Your ref: Docket No. 52-006
Our ref: DCP/NRC1599

SUBJECT: Transmittal of Westinghouse Responses to Open Items Identified in the AP1000 Draft Safety Evaluation Report

Westinghouse Non-Proprietary Response to AP1000 Draft Safety Evaluation Report (DSER) Open Items

AP1000 DESIGN CERTIFICATION REVIEW

Figure 3.7.2.3-1-8: Maximum Dynamic Subgrade Pressure Distribution

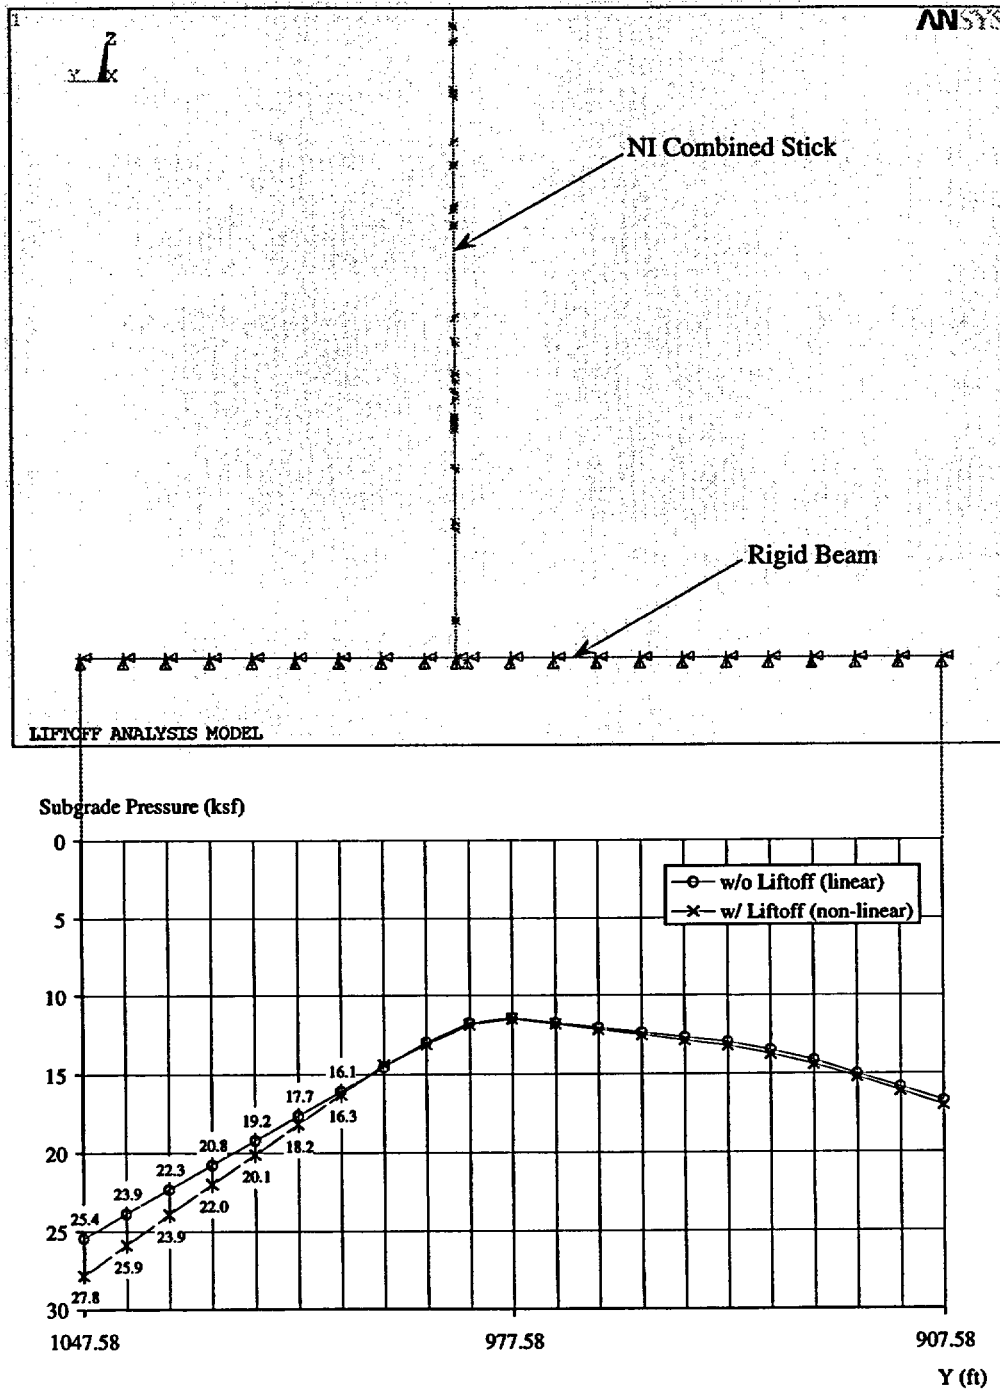
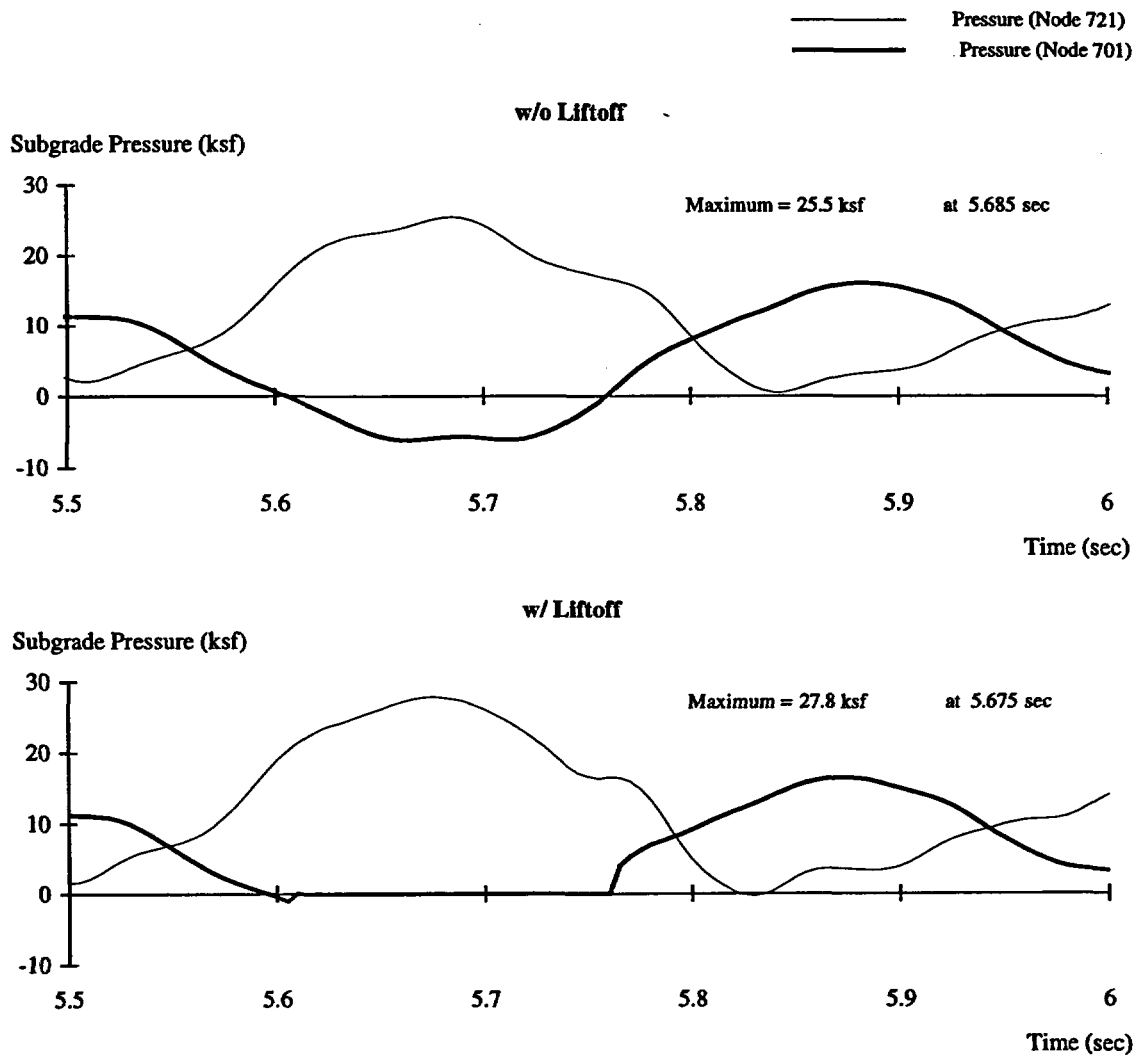
Depending on the outcome of the comparisons from the two separate analyses discussed above, one for the uplift effect and the other for stiffness reduction, the design calculations for the certified design may have to be revised. This is Open Item 3.7.2.3-1.

Figure 3.7.2.3-1-8 shows the maximum dynamic subgrade pressure during the analysis. Figure 3.7.2.3-1-9 shows the time history of the pressure at the west and east edges around the time that the peak pressure occurs at the west edge. Lift off has a small effect on the subgrade pressures close to the west edge with insignificant effect beneath most of the equivalent rectangular basemat. The effect on the pressure at the west edge is significantly less than that

calculated in the basemat analyses using equivalent static accelerations. Figure 3.7.2.3-1-10 shows two time history basemat displacements, one that occurs at the time of maximum lift off and one that occurs at the time of maximum soil pressure. These time history displacements are compared to basemat displacements equivalent static analyses. The upper figure shows linear (no lift-off effect) analysis results and the lower figure shows non-linear (lift-off effects) analysis results. In the linear analyses, the differences between dynamic and static displacements are small. The differences are larger in the non-linear analyses. The table below shows the seismic overturning moments and vertical forces in the equivalent static analyses and in the time history analyses at the time that peak pressure occurs at the west edge.

Figure-1: Schematic of Rotor Stress During Start-up

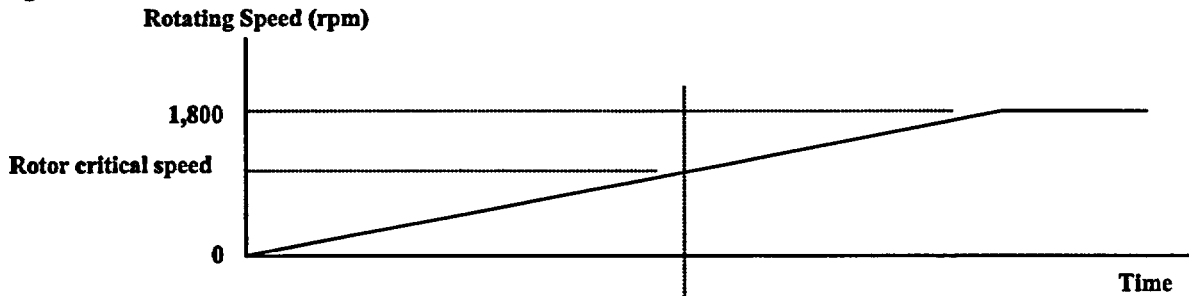
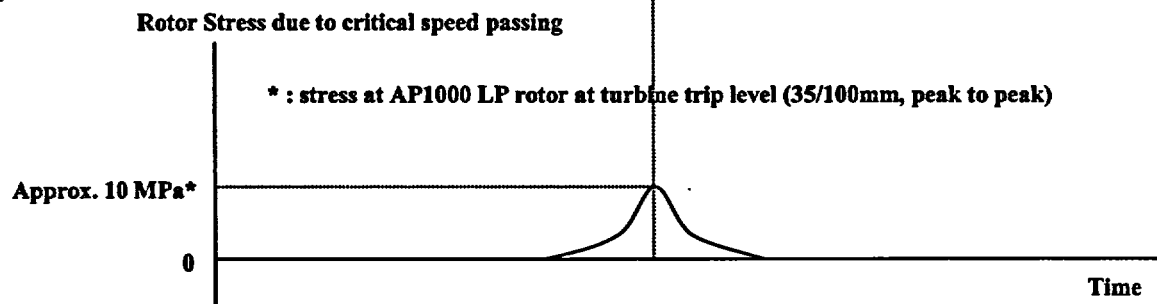
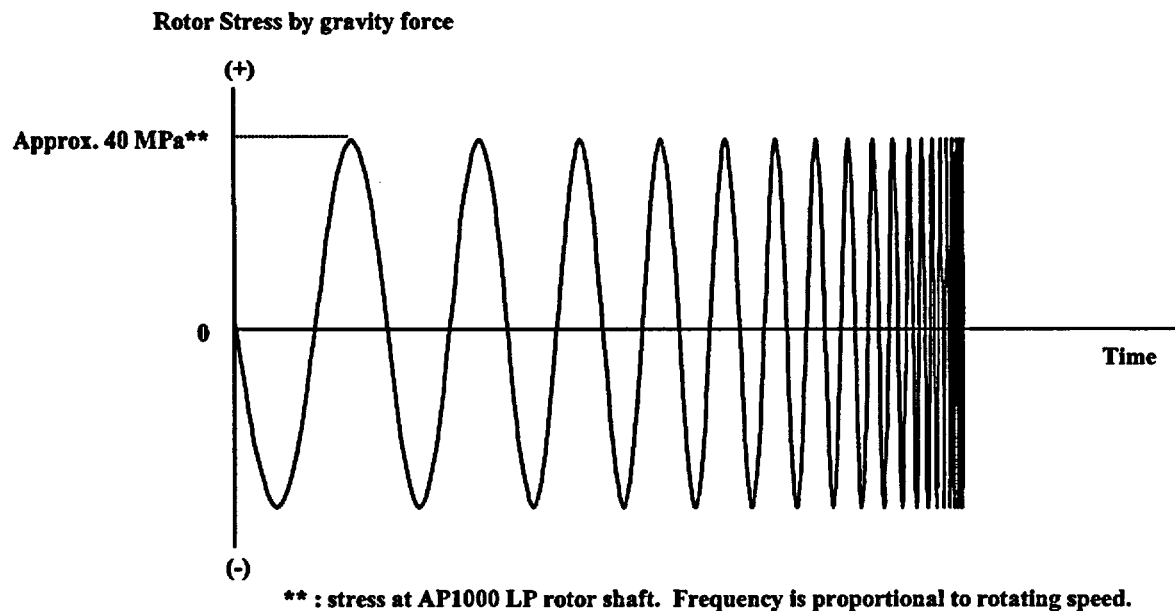
DCD Tier 2 Section 10.2.3.2.1 described a brittle fracture analysis considering the design duty cycle stresses, number of cycles, ultrasonic examination capability and growth rate of potential flaws. In its response to RAI 251.025 regarding the conservative factors of safety that were included in estimating the above-mentioned parameters, Westinghouse referred to the low cycle fatigue (LCF) crack analysis of WCAP-15783. (WCAP-15783 is used to support the NRC staff's review of turbine missiles in DCD Tier 2 Section 3.5.1.3, as well as to support the turbine rotor integrity of DCD Tier 2 Section 10.2.3.) The brittle fracture analysis described in Section 10.2.3.2.1 is completely contained in WCAP-15783. The staff considers this response appropriate because it is clear that the operational stresses in the shaft are much lower than the operational stresses in the disks, making the disks more limiting than the shaft. Hence, the WCAP-15783 analyses for disks are sufficient for assessing overall rotor integrity.

In the revised WCAP-15783, Westinghouse replaced an unreasonable K_{Ic} value used in the LCF analysis, as identified in RAI 251.025, by a reasonable proprietary value. In its response to RAI 251.026 dated March 25, 2003, regarding the vibratory stresses, Westinghouse referred to WCAP-15783 and stated that "(t)he vibratory stress when passing through critical speeds during startups and shutdowns is not included in the evaluation of low cycle fatigue. This is because the bending stress for this condition is greatest on the surface of the rotor and negligibly small on the rotor bore surface, which is the point where maximum stress of low cycle fatigue appears." The NRC staff considers this to be appropriate because the vibratory stress occurred at a different location, not the place where LCF effect is evaluated. However, the response has not provided adequate justification to conclude that rotor resonant stresses resulting from passing through rotor critical speeds are insignificant. This is DSER Open Item 10.2.8-2.

Rotor resonant stress is not an alternating stress, but is a static stress. As the turbine speed increases from rest passing through resonance (See Figure 1-A), the maximum turbine trip displacement is 35/100 mm, peak to peak with a force amplitude of approximately 10 MPa. (See Figure 1-B).

The rotor stress developed by gravity force or by possible misalignment of the bearings is evaluated in section 4.2 of WCAP-15783 and is a high cycle alternating stress and the stress behavior is schematically shown in Figure 1-C.
